UNITED STATES PATENT AND TRADEMARK OFFICE

APPLICATION NO.	FILING DATE	FIRST NAMED INVENTOR	ATTORNEY DOCKET NO.	CONFIRMATION NO.
09/621,975	07/21/2000	Noah P. Montena	8958-0026	5489

Office Action Summary

Application No.
09/621,975

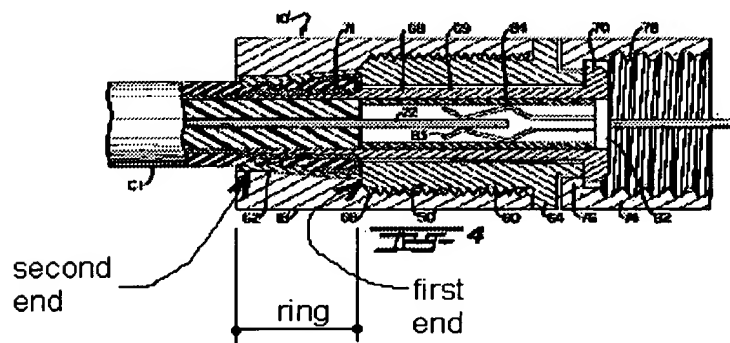
4. Claims 2, 8, 10, 12 and 15-20 are rejected under 35 U.S.C. 102(e) as being anticipated by Holliday '220. The connector of Holliday is for coupling to the end of

a coaxial cable C1 having a center conductor 22, a dielectric, a grounding sheath and an outer protective jacket. The connector comprises a tubular post 69 with a first end 71 inserted into the end of the cable, and an opposed second end 70; and a nut 74 rotatably engaging the second end of the post and having an opposed second end with internal threads 78. The connector further comprises a cylindrical body member 60 with a sleeve 62 and an open rear end portion at the left end. The second end of the body member

(the right end) engages the second end 70 of the post at its second end. The compression ring (indicated at left) has first and second ends as shown. Between the ends, the ring comprises an inwardly tapered

annular wall that causes deformation of the sleeve. It is noted that the threaded portion to the right of the compression ring is seen to be an attachment part of the splicing device and not a part of the compression ring.

In regard to claim 8, the body member of Holliday comprises an enlarged shoulder just to the left of the beginning of the thread 66.

In regard to claim 10, the thinner section to the right of rib 38 (see Fig. 1 for reference numeral 38) is seen to be a relief that facilitates bending of the sleeve.

In regard to claim 12, the sleeve of Holliday comprises a corrugated portion 38, 40. As this structure assists in compressing the cable, it is also seen to facilitate movement of the sleeve.
